Date:	6 February 2023	Contact name:	Greg Britton
Your reference:		Telephone:	+61 2 8854 5000
Our reference:	8A0132_L006.F01-addendum response	Email:	greg.britton@rhdhv.com

**PPSSTH-176 – SHELLHARBOUR – DA0276/2021 – COVE BOULEVARD, SHELL COVE -  
PRECINCT H SUBDIVISION**  
**Addendum to Response to Comments from Southern Regional Planning Panel**

Figure 2-1 2125 coastal hazard zones (ZSA and ZRFC) for SSP2-4.5 (Intermediate)  
(source: Advisian, January 2023)

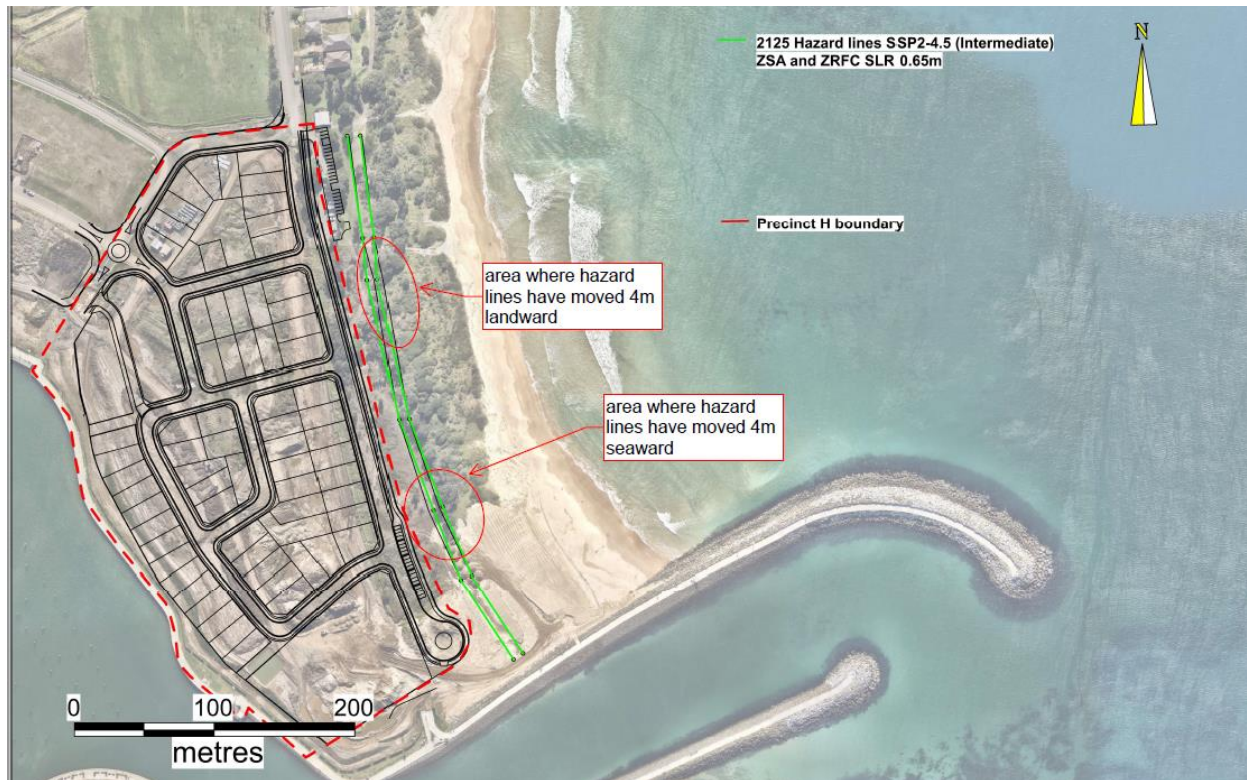
In recent discussions between Council staff and Frasers Property clarification has been sought by Council regarding the dune crest levels adjacent to Precinct H adopted in the modelling by Advisian to determine the 2125 ZSA and ZRFC.

The re-determined position of the 2125 ZSA and ZRFC for the three sea level rise scenarios are shown in Figures 2-1, 2-2 and 2-3, together with the previous positions (in black). Advisian has included a notation on the Figures where the hazard lines have moved from their previous positions (up to 4m landward and up to 4m seaward).

Based on examination of the re-determined hazard zones the conclusions reached in my letter of 8 December 2022 do not change, ie. the predicted 2125 erosion/recession hazard is not considered to be a concern for Boolwarroo Parade or the carparks on the eastern side of Boolwarroo Parade.
